**SUBDIVISION REVIEW SHEET****CASE NO.:** C8-2016-0216.0A**ZAP DATE:** October 3, 2017**SUBDIVISION NAME:** Allen Terrace Subdivision**AREA:** 1.98**LOT(S):** 5**OWNER/APPLICANT:** (John Dan McMahan III and Artemis Land Partners)**AGENT:** (Rivera Engineering)**ADDRESS OF SUBDIVISION:** 1401 Allen Road**GRIDS:** MF22**COUNTY:** Travis**WATERSHED:** Eanes Creek**JURISDICTION:** Full-Purpose**EXISTING ZONING:** Single Family**MUD:** N/A**NEIGHBORHOOD PLAN:** N/A**DISTRICT:** 8**PROPOSED LAND USE:** SF-2**ADMINISTRATIVE WAIVERS:**

Re: **Allen Terrace Subdivision – 1401 Allen Road**  
**Final Subdivision Plat Case No. C8-2016-0216.0A**  
**Formal Request for Variance from LDC Section 25-4-175(A)(2)**

**SUBJECT:** C8-2016-0216.0A Allen Terrace Subdivision, Flag Lot variance request

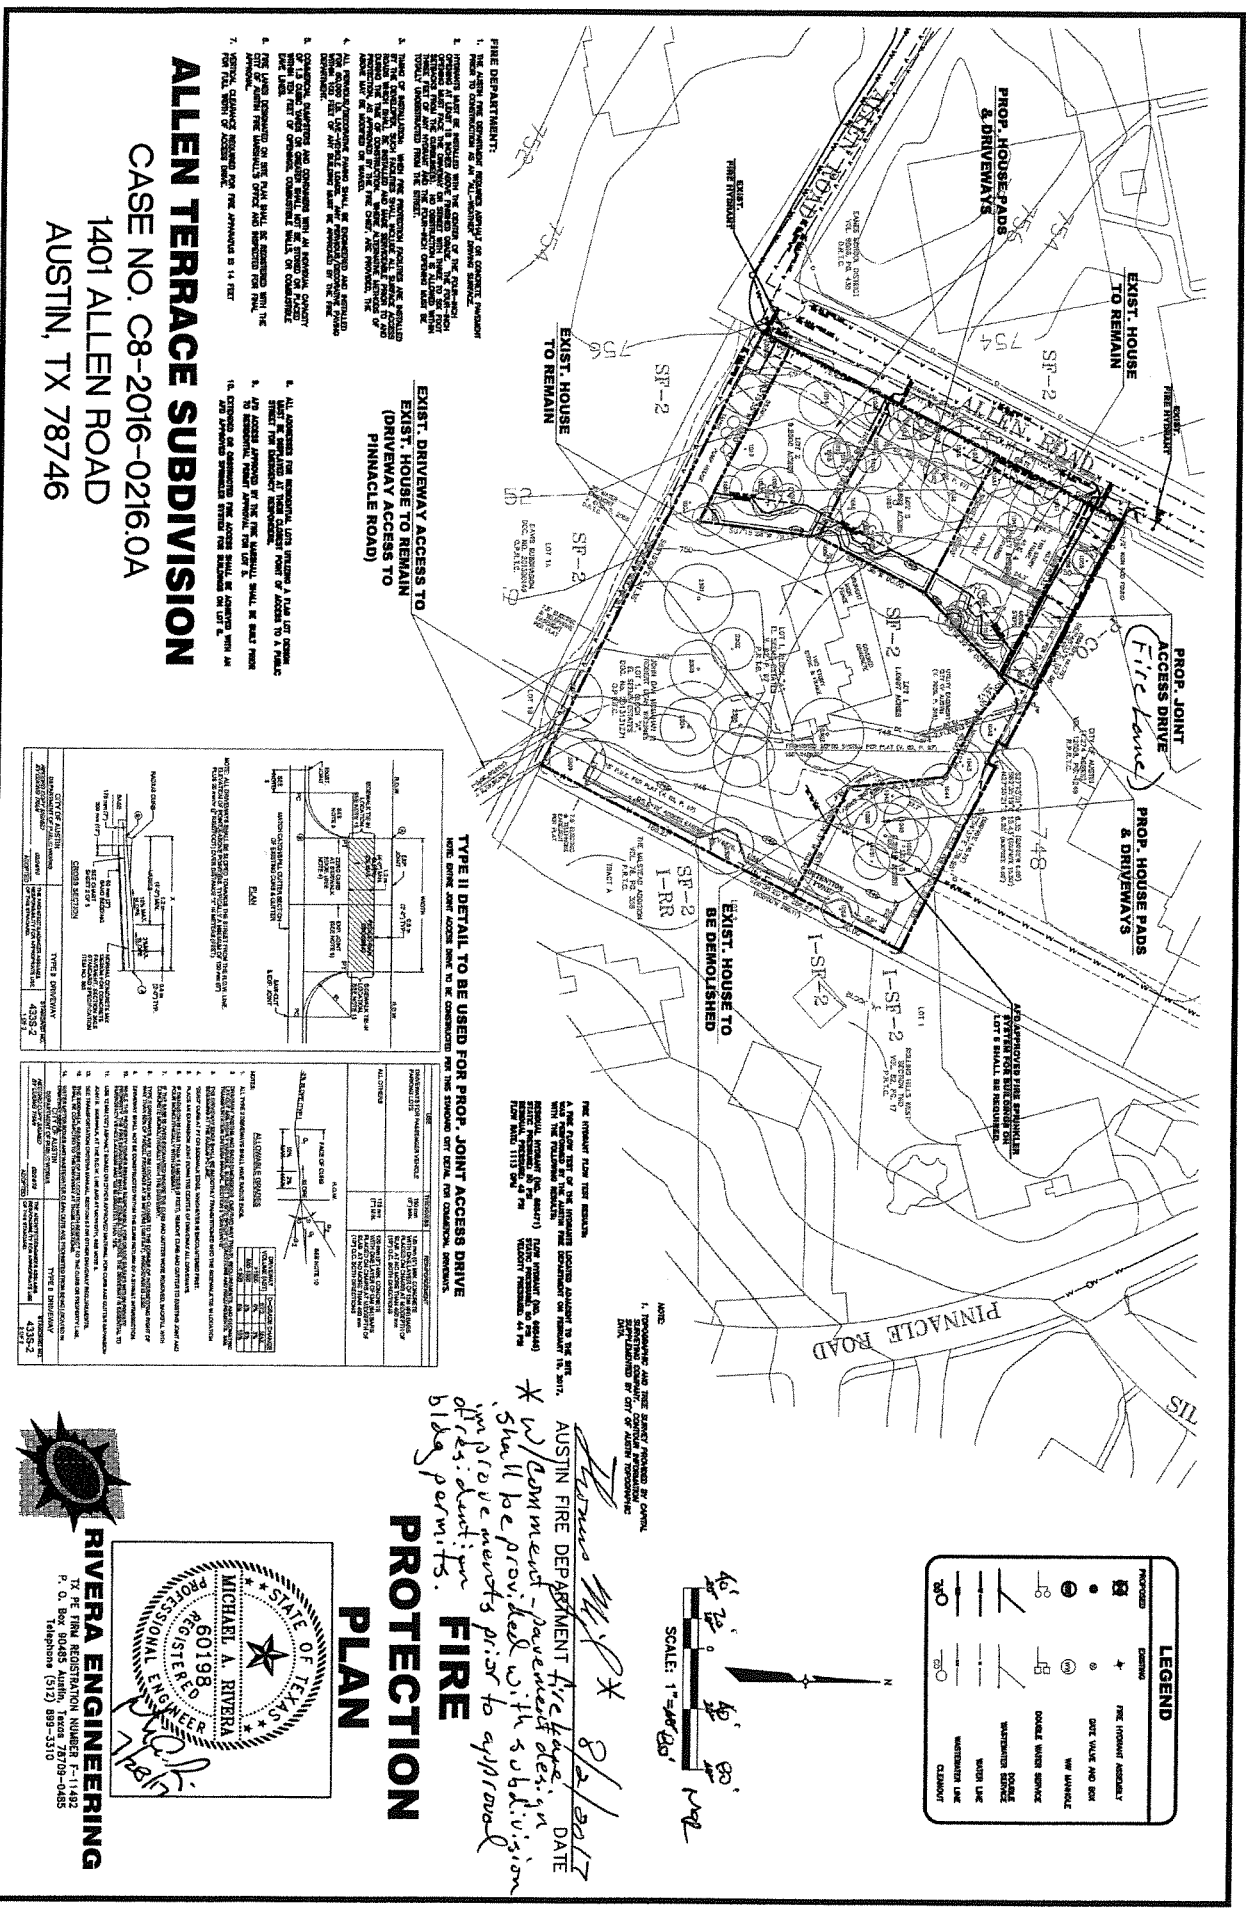
*The entire area is zoned SF-2 which is the appropriate zoning for the proposed use. The proposed use, detached single-family residential is compatible with existing neighborhood conditions. There are other examples of flag lots in the immediate vicinity.*

**DETAILED WATER & WASTEWATER SERVICE PLAN**

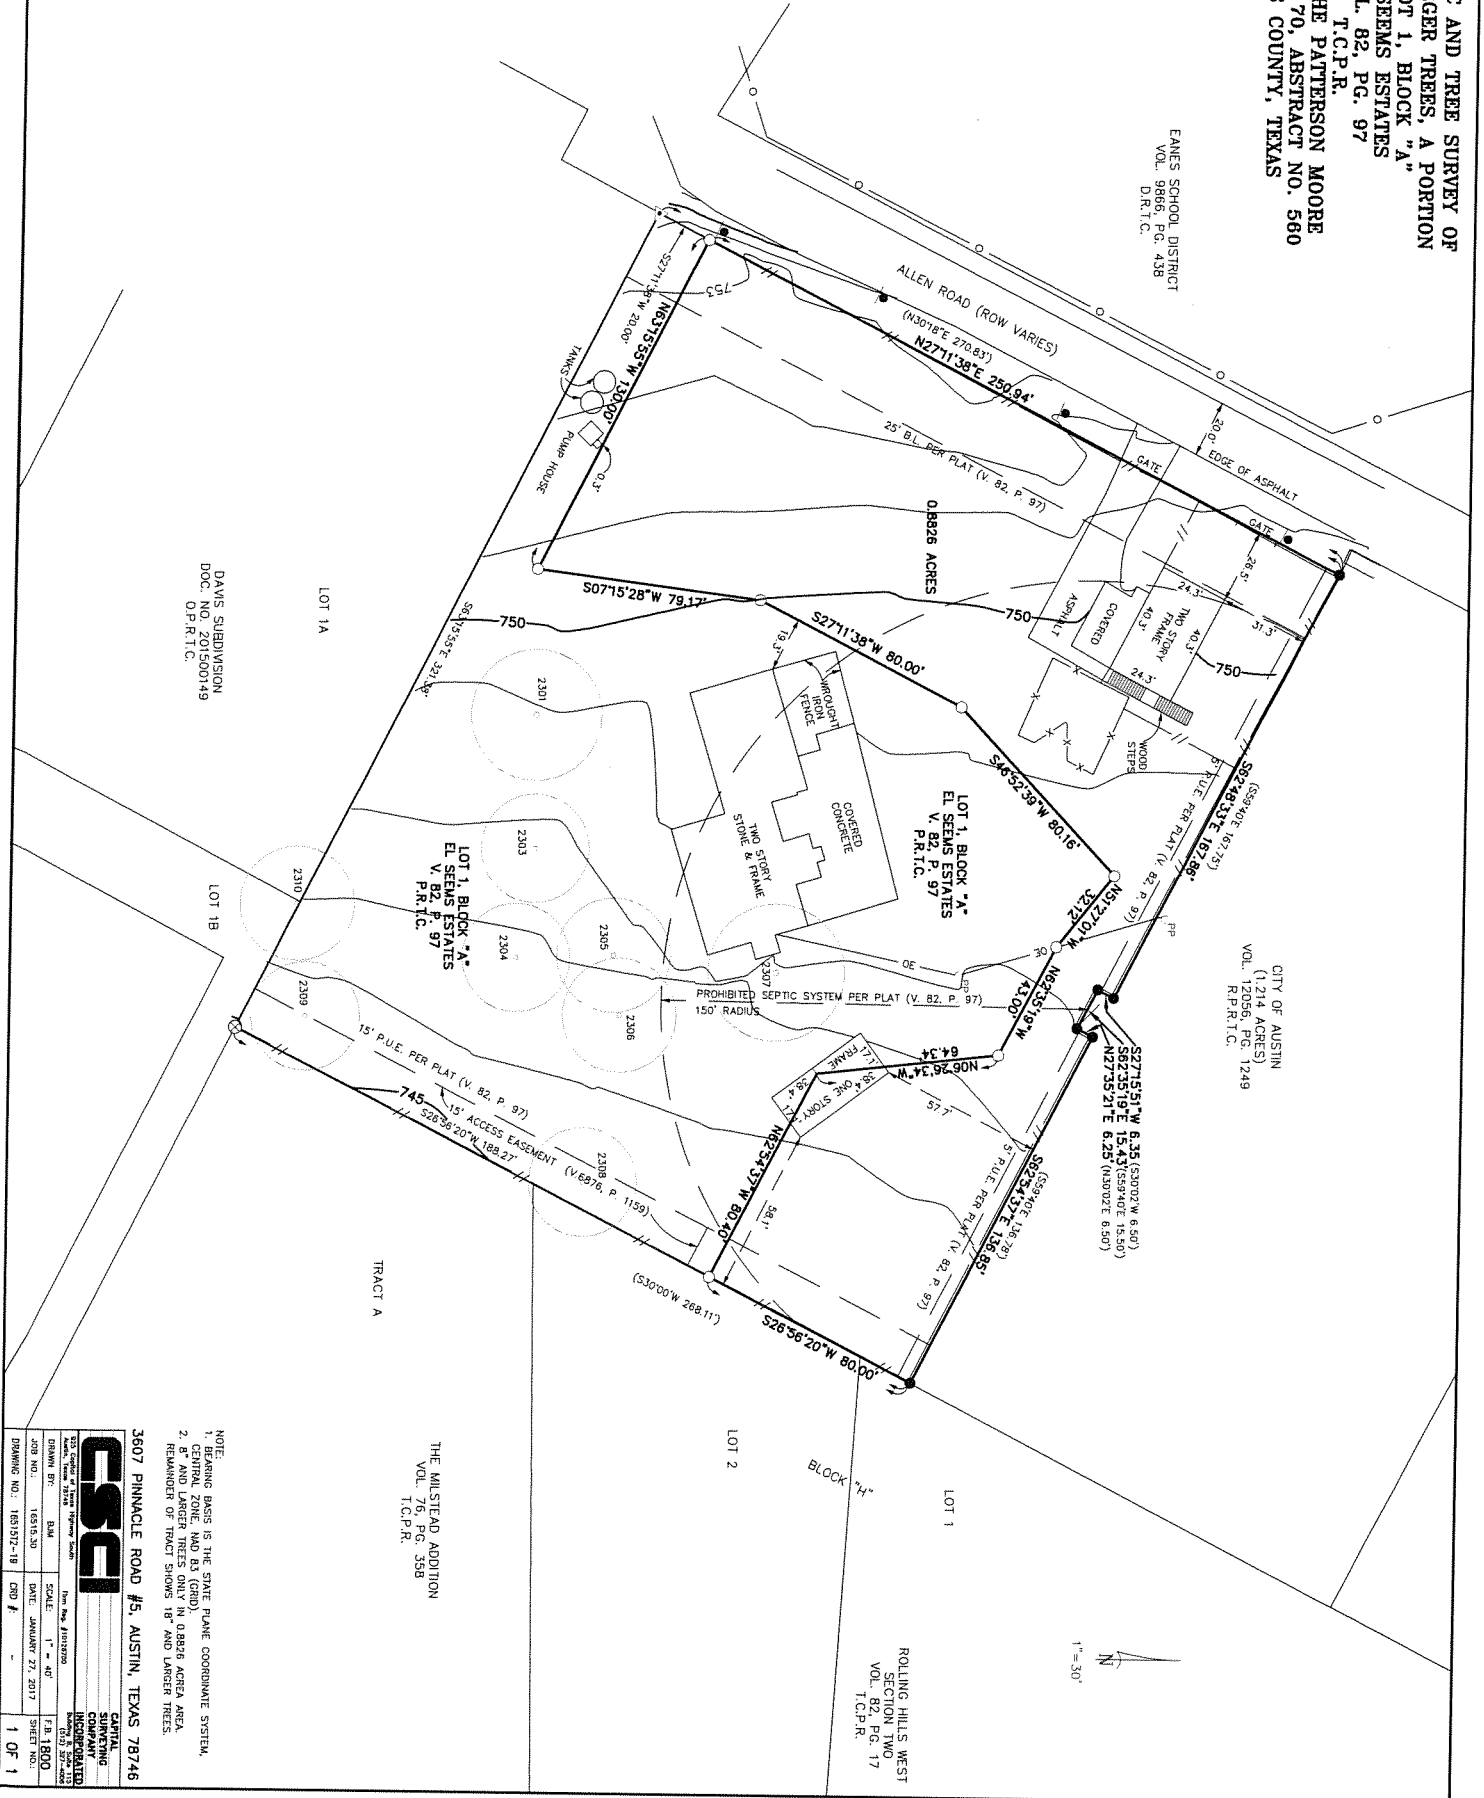
*The applicant has provided a driveway and utility plan to reviewers for the City of Austin Water and Wastewater review and Austin Energy Departments. The reviewers have determined after review of the utility/driveway plan that there is adequate room to provide utility service to both lots and utilities will not cross the proposed new lot lines.*
